Technical Assistance Services for Communities
Contract No.: EP-W-07-059
TASC WA No.: TASC-3-R2
Technical Directive No.: TASC-3-R2-001 Quanta Community
Advisory Group

Report on:
Quanta Resources Superfund Site
Technical Summary of Areas of Community Concern with the
Remedial Investigation, Feasibility Study and Proposed Plan
November 8, 2010

Plan view of the Quanta Resources Superfund Site

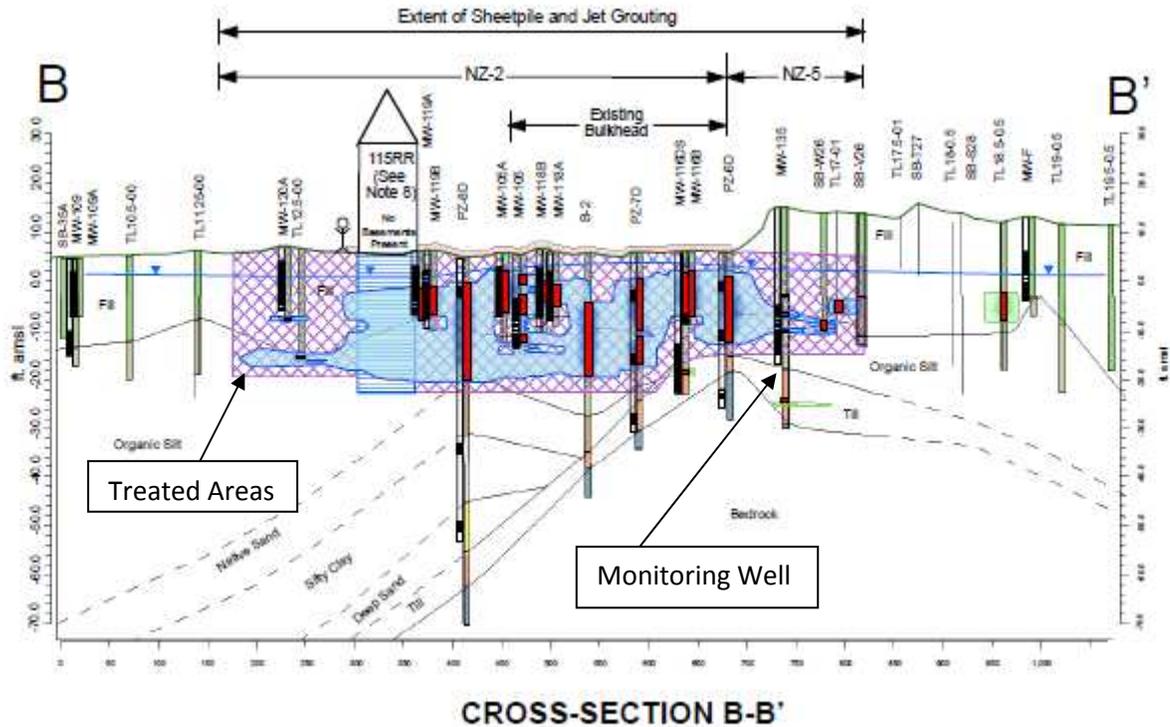
QCAGE members were concerned that the figures in the Feasibility Study containing cross-sections were not easy to understand. They requested assistance in understanding them.

The cross-sectional figure above (EPA Feasibility Study 2010, Figure ES-9) shows what the ground beneath the surface looks like when looking at the site from the river, with the down river end on the left (labeled B) and upriver on the right (labeled B'). The sampling and monitoring wells extend top-to-bottom into the ground. The earth that will be cleaned up is shown as shaded areas beneath the surface. Further discussion on cross-section interpretation will be given during the oral presentation on November 4, 2010.
